**UNITED STATES OF AMERICA
DEPARTMENT OF TRANSPORTATION
FEDERAL AVIATION ADMINISTRATION
RENTON, WASHINGTON 98055-4056**

Israel Aircraft Industries, Ltd.

Regulatory Docket No. FAA-2003-15565

GRANT OF EXEMPTION

FIGURE 1 - 9g NET DISTENTION

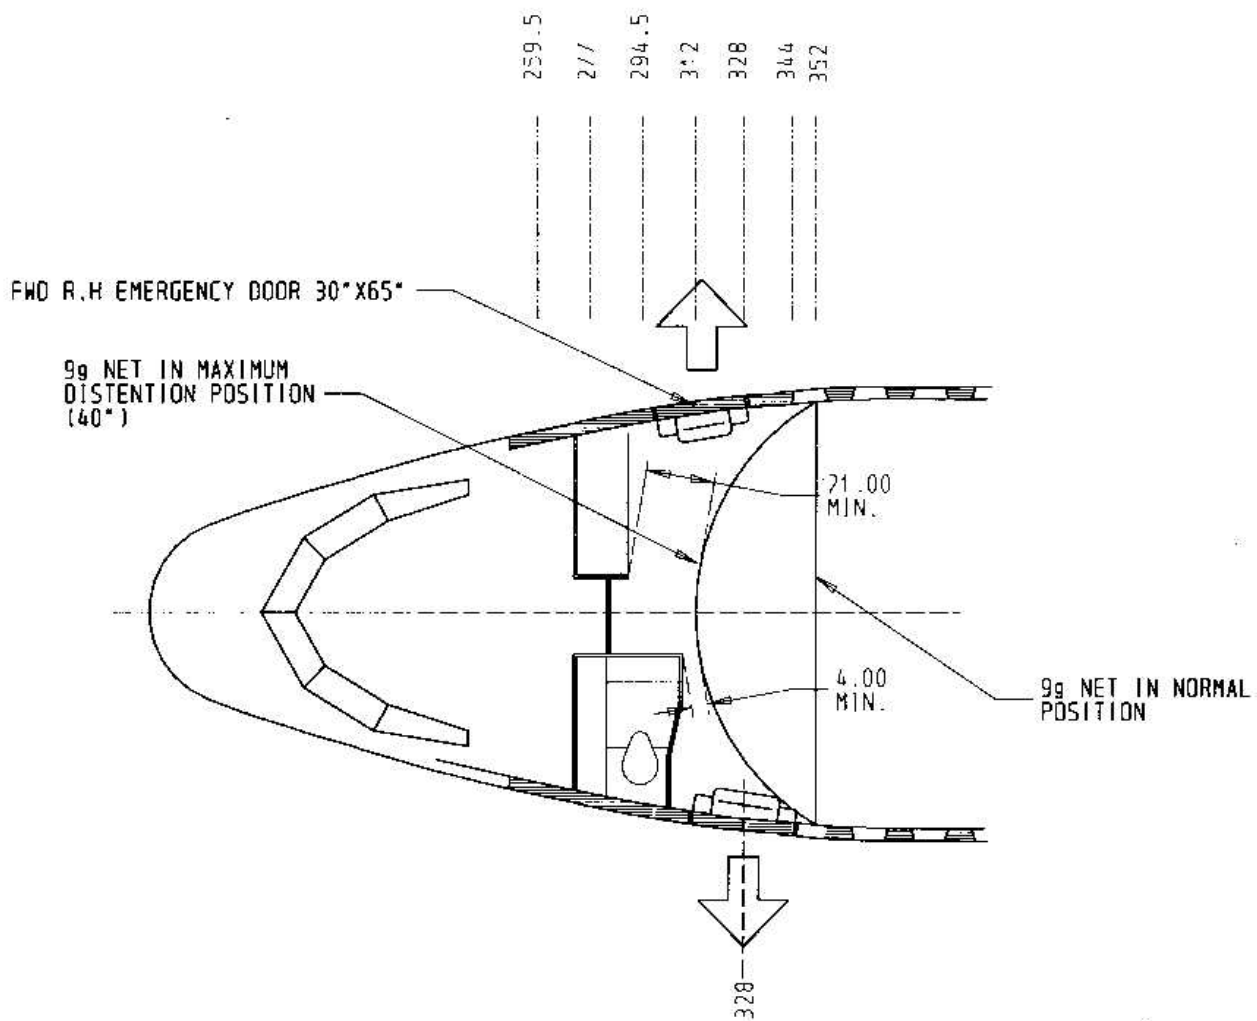
“Figure 1 shows the location of the 9G net at the free position and the position of the net after distention at 9G forward crash condition. At crash condition the net will not impact the lavatory, a minimum of 5" gap is maintained and a clear emergency path of minimum 21" is available to the right hand service door (DOOR 1R). This exceeds the minimum 20 inch required.

“In the crash condition with the net at the maximum distension the crew/supernumerary will be able to open the door that opens first inward and forward and then swings outboard. Also opening the door from outside is possible. In the 9G forward crash condition all the loads are transferred aft into the net attachments that are attached to the aircraft skin, distributed all around the fuselage (16 points) and into the floor structure (8 points), and is transferred aft to the aircraft skin and stringers. The structure around the door will not sustain any damage or deformation that could jam the door.

The petitioner has requested an exemption from § 25.783(h) which requires the passenger entry door to qualify as an emergency exit. The petitioner has indicated that access to the passenger entry door would be blocked by cargo restrained by a net during an emergency landing. The FAA finds it acceptable for the passenger entry door to not qualify as an emergency exit per § 25.783(h) since other emergency exits will be provided and each supernumerary will receive evacuation training on the use of these emergency exits.

Section 25.807(g)(1) requires an exit, which meets the minimum size of a Type III exit, on each side of the airplane. The petitioner's design includes three emergency exits: a right side flightdeck window exit, a left side flightdeck window exit and the right side door 1 exit. The right side door 1 exit meets the minimum size requirements of a Type III exit, but is only considered acceptable as an emergency exit for the supernumeraries if the flightdeck door is latched open during taxi, takeoff and landing to allow clear access from the flightdeck to the exit. However, the FAA considers that an acceptable level of safety will be provided for two supernumeraries by the flightdeck window exits. This determination is based on the number of supernumeraries on the flightdeck being limited to two and requirements that the supernumeraries have a higher level of training and be physically more capable of evacuating the airplane through these smaller exit openings than typical passengers.

In consideration of the foregoing, I find that a grant of exemption is in the public interest and will not affect the level of safety provided by the regulations. Therefore, pursuant to the authority contained in 49 U.S.C. §§ 40113 and 44701, delegated to me by the Administrator, Israel Aircraft Industries, Ltd., is hereby granted an exemption from §§ 25.783(h), 25.807(g)(1), 25.807(i)(1), 25.810(a)(1), 25.813(b)(3), 25.857(e) and 25.1447(c)(1). The petition is granted to the extent required to permit type certification of Boeing Model 737-300 airplanes which have been converted from a passenger to a freighter configuration with provisions for the carriage of supernumeraries. The following limitations apply and must be documented in the limitations section of the Airplane Flight Manual:

1. A maximum of two supernumeraries may occupy the flightdeck.
2. Supernumeraries are limited to the categories specified in § 121.583(a)(1) through (a)(7).

3. Each supernumerary must be briefed by a flight crewmember on the use of the exits and emergency equipment prior to each flight.
4. The operator must determine that each supernumerary is physically able to accomplish the necessary emergency procedures.
5. Supernumeraries are prohibited from being in the cargo area aft of the net during flight. The preflight briefing must inform supernumeraries of this requirement.
